**COLORADO DIVISION OF RECLAMATION, MINING AND SAFETY**  
**MINERALS PROGRAM INSPECTION REPORT**  
**PHONE: (303) 866-3567**

<b>MINE NAME:</b> Bridalveil Pit	<b>MINE/PROSPECTING ID#:</b> M-2001-054	<b>MINERAL:</b> Gravel	<b>COUNTY:</b> Ouray
<b>INSPECTION TYPE:</b> Multi Person Inspection	<b>INSPECTOR(S):</b> Wallace H. Erickson & G. Russell Means	<b>INSP. DATE:</b> August 29, 2012	<b>INSP. TIME:</b> 10:30
<b>OPERATOR:</b> Bridal Veil Construction	<b>OPERATOR REPRESENTATIVE:</b> Emery Lynn Olin	<b>TYPE OF OPERATION:</b> 110c - Construction Limited Impact	
<b>REASON FOR INSPECTION:</b> Normal I&E Program	<b>BOND CALCULATION TYPE:</b> Complete Bond	<b>BOND AMOUNT:</b> \$4,942.00	
<b>DATE OF COMPLAINT:</b> NA	<b>POST INSP. CONTACTS:</b> None	<b>JOINT INSP. AGENCY:</b> None	
<b>WEATHER:</b> Cloudy	<b>INSPECTOR'S SIGNATURE:</b> <i>Wallace H. Erickson</i>	<b>SIGNATURE DATE:</b> September 12, 2012

Bridalveil Pit  
M-2001-054  
August 29, 2012  
Photo 3

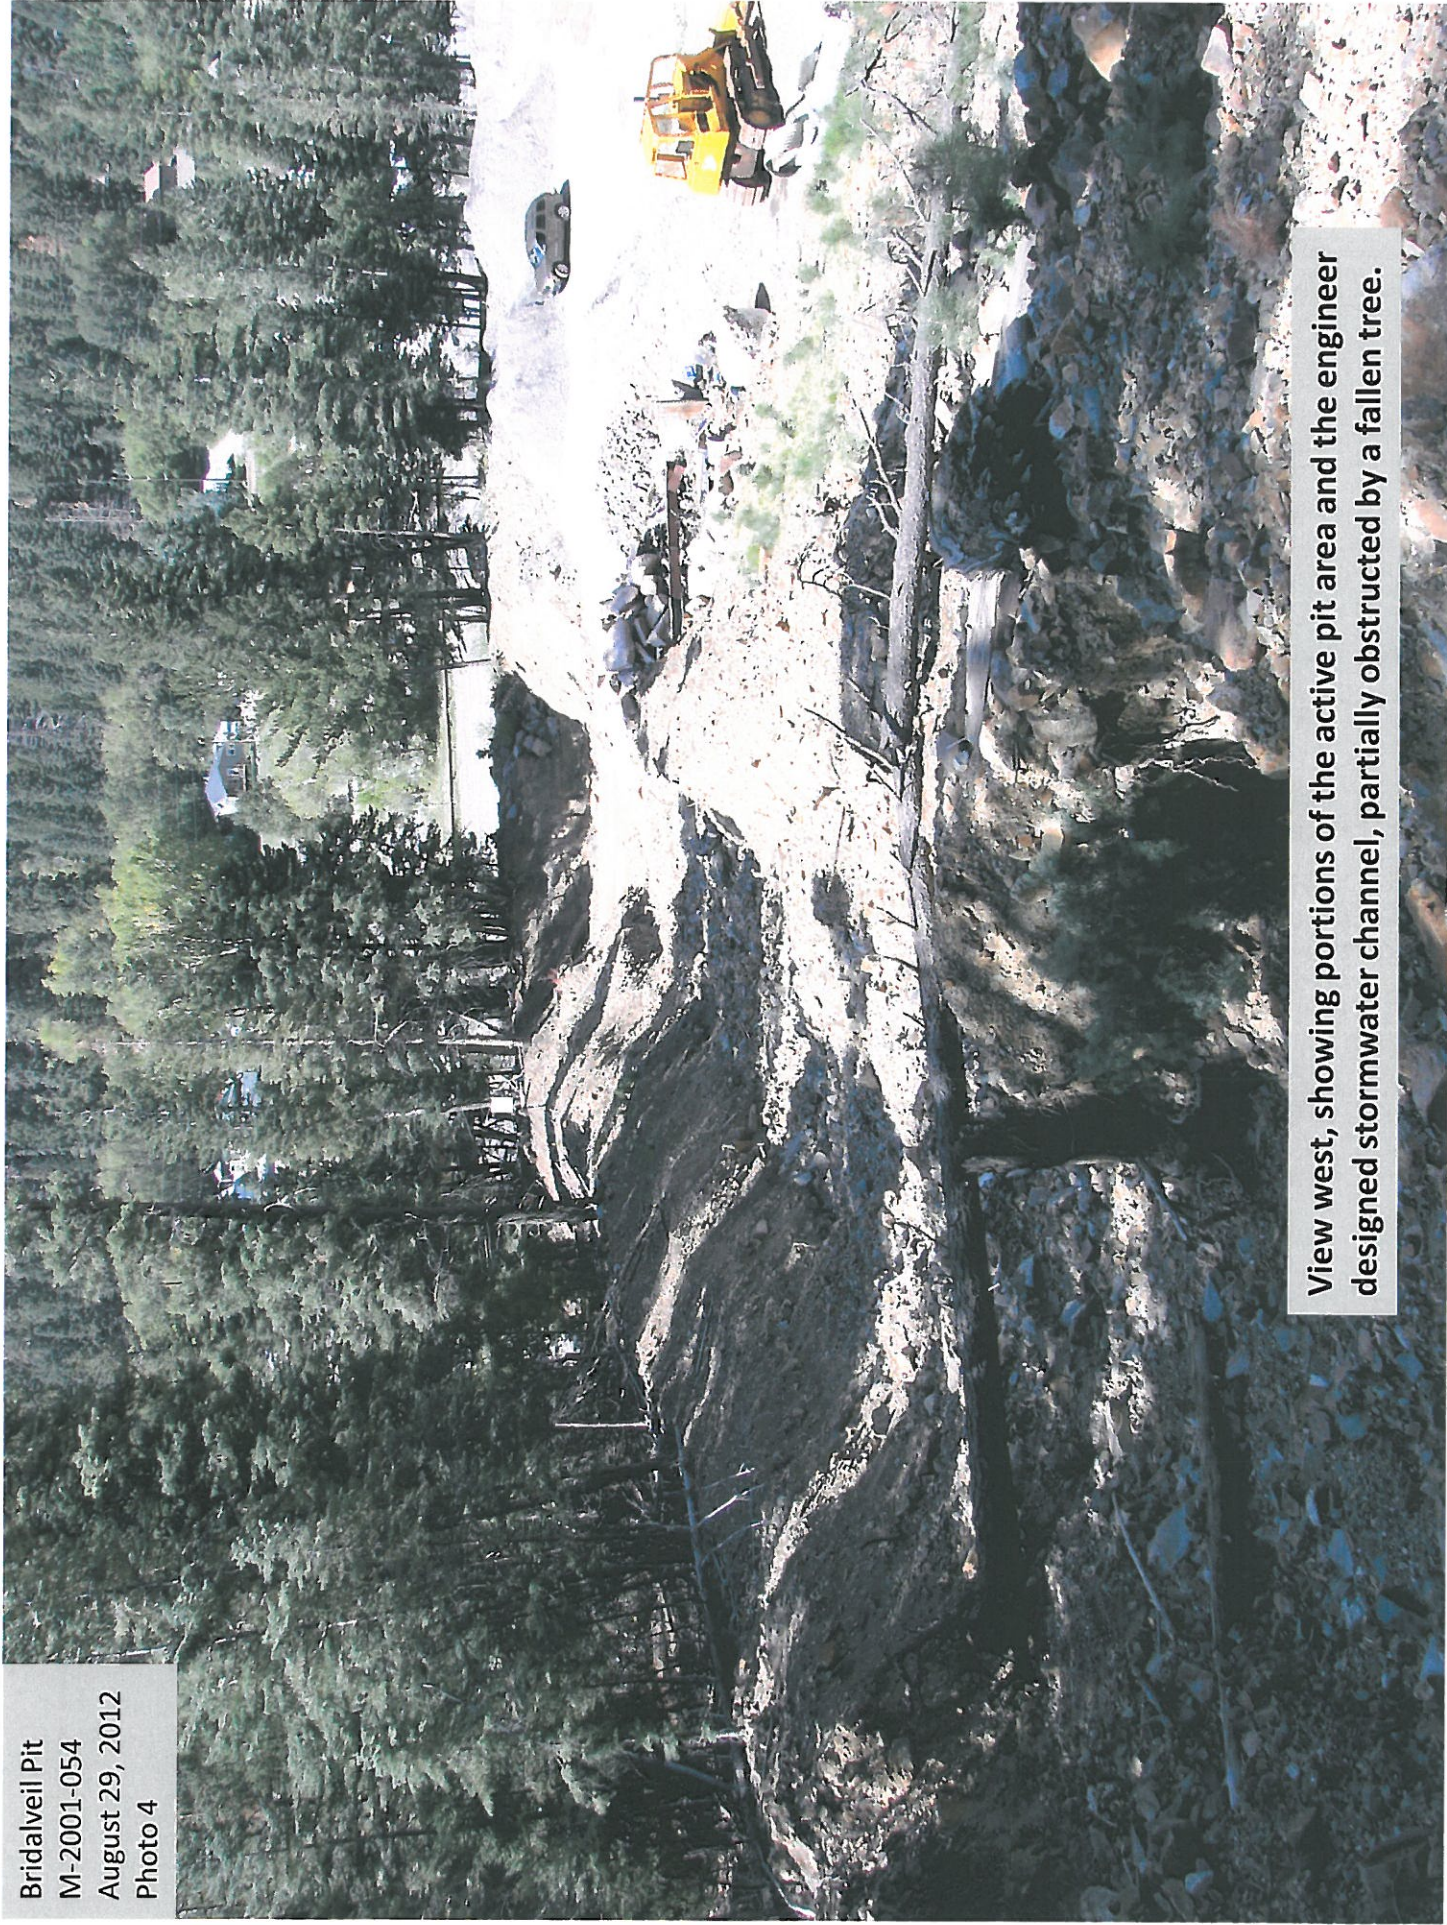
As shown in photos 2 and 3, earthen materials appear to have been imported from off-site areas and are being utilized as backfill. Permit documents do not indicate importation of materials was intended or that imported materials would be utilized as structural fill. Permit documents do not include the notice from the Operator required under Rule 3.1.5(9), addressing the imported materials. As noted above, the Division has identified the issue as a problem and has imposed a 30-day corrective action deadline whereby the issue must be resolved.

View west, taken from the east boundary of affected lands, showing the active pit area. The stockpiled materials and portions of the backfill materials exhibiting grey coloration appear to have been imported from off-site areas.

**CORRECTIVE ACTIONS:** Within 30 days, due October 12, 2012, the Operator shall provide a notarized affidavit, stating that the fill is, in fact, inert and addressing all requirements of Rule 3.1.5(9), which describes the intended use of inert/off-site fill by the corrective action date.

Bridalveil Pit  
M-2001-054  
August 29, 2012  
Photo 6

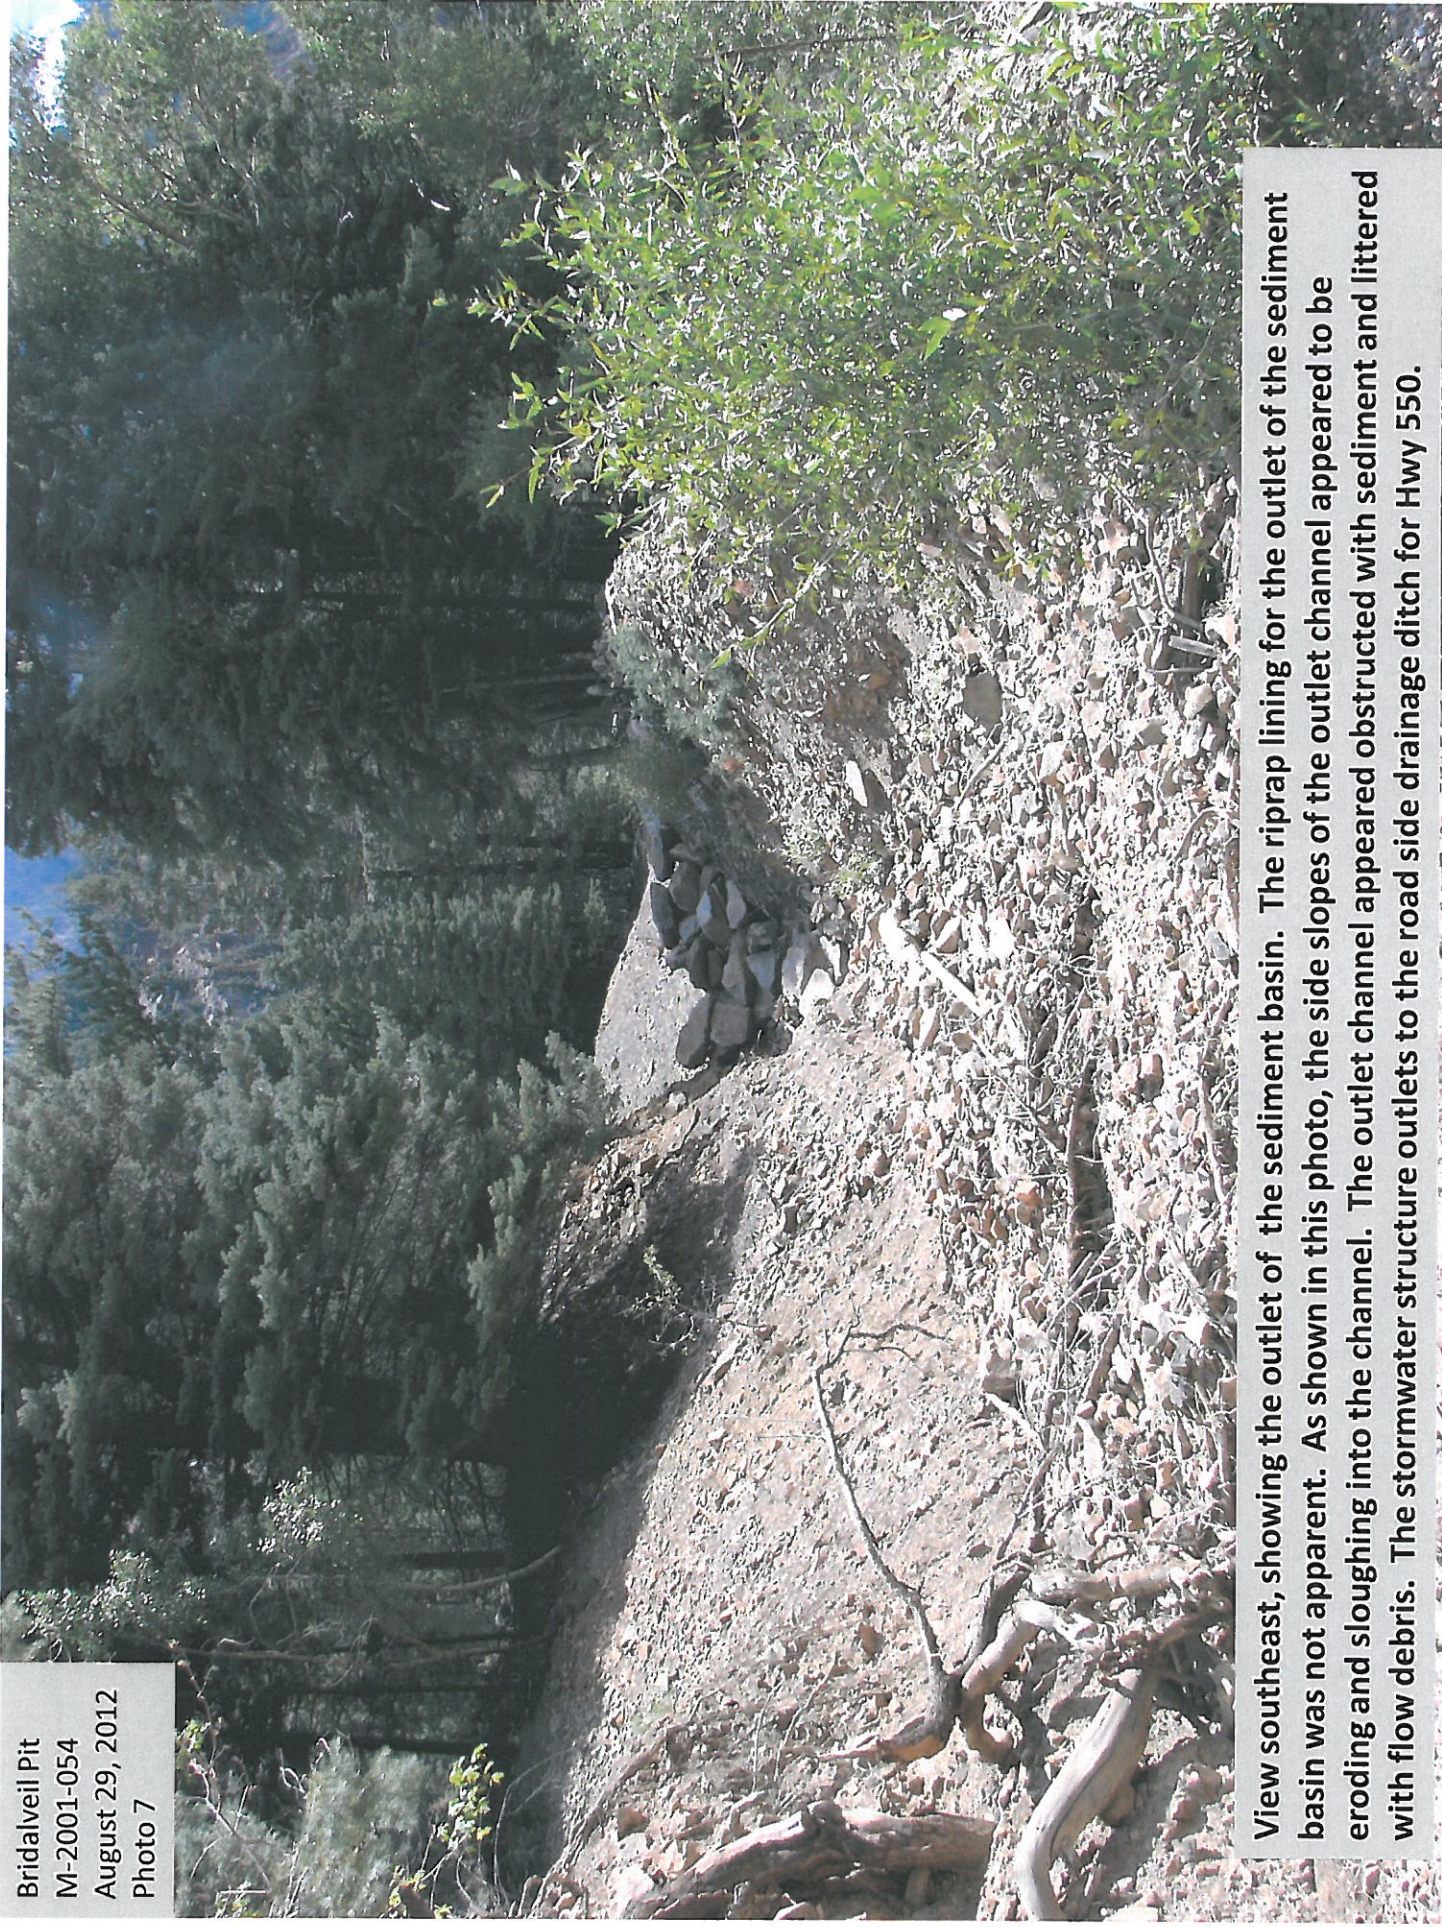
**PROBLEM/POSSIBLE VIOLATION:** Problem: The Operator is not maintaining the stormwater control channel or its associated sediment basin in accordance with the approved plan. The approved plan was designed and certified by a licensed professional engineer. Evidence of excessive erosion and sedimentation were observed. Pursuant to C.R.S. 34-32.5-116(4)(i) and (j), the Operator is required to stabilize affected lands so as to effectively control erosion and protect outside areas from damage.

View west, showing the sediment basin for the stormwater channel. According to the approved design, the basin is to be approximately 50 feet wide, 35 feet long, with 0.7H:1V side slopes and 12 feet deep. The inlet and outlet for the basin are to be lined with riprap. As shown in this photo, the sediment basin has not been maintained in accordance with the approved design.

**CORRECTIVE ACTIONS:** Within 30 days, due October 12, 2012, the Operator shall repair the stormwater control channel and basin to fully comply with the approved plan, control erosion, and protect outside areas from damage. By October 12, 2012, the Operator shall provide photo documentation to the Division verifying the completion of repairs for all portions of the stormwater control structures.
